— **Commission Energy 2030** —

**Review Process**

**Answers to Questions 10-13 by Review Panels**

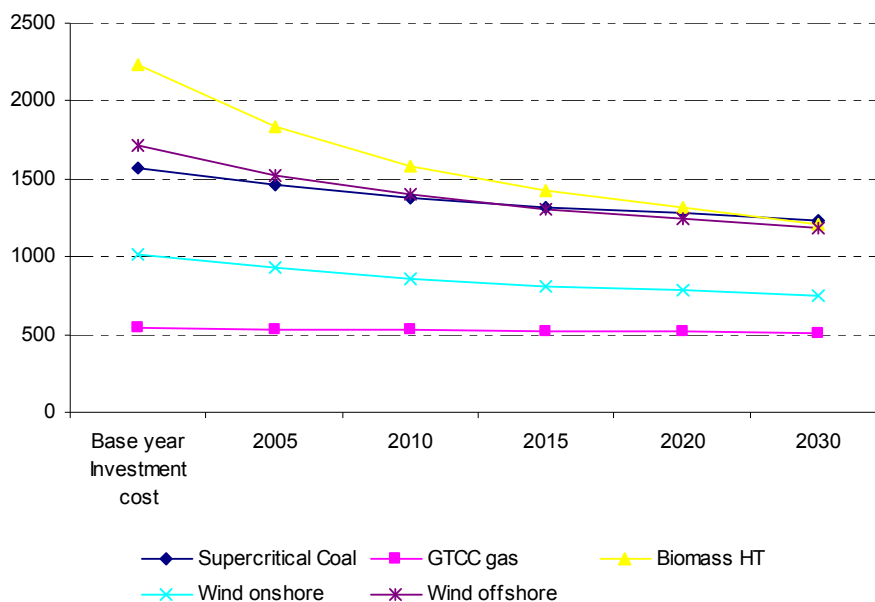
<b>CREG</b>		
<b>N°</b>	<b>Auteur</b>	<b>Question</b>
<b>13</b>	<b>Bart De Waele</b>	1. Welke zijn de technico-economische parameters (rendement, gebruiksduur, beschikbaarheid, investeringskost, vaste kosten, variabele kosten, ...) die voor elke technologie werden gebruikt? Hoe evolueren deze parameters tussen nu en 2030?

Most power generation technologies referred to in the FPB and CE2030 reports are aggregates of more detailed technologies. The model results we have at our disposal relate to aggregates and not to individual technologies. For instance, the aggregate "wind off-shore" combines various wind "technologies" whose production costs differ according to their location (impact on utilisation rate), their size, etc. Consequently, it is not possible to establish a direct link between the techno-economic data of individual technologies (more than 60 power technologies in the PRIMES data base) and the model results. Moreover, the investment costs may vary according to whether a new plant is built on greenfields or on an existing site (see the answer to question 8.4 on nuclear).

Given this particular feature of the model, it is not possible to give an extensive description of all power generation technologies. Instead, we have plotted the evolution of the investment costs (which is the most important cost parameter with the fuel costs) of some key power generation technologies (see figure below; expressed in EUR/kW). Investments costs relate to new plants on greenfields and for wind we have selected those with an annual

utilisation rate of 2100 hours for onshore wind and of 2630 hours for offshore wind.
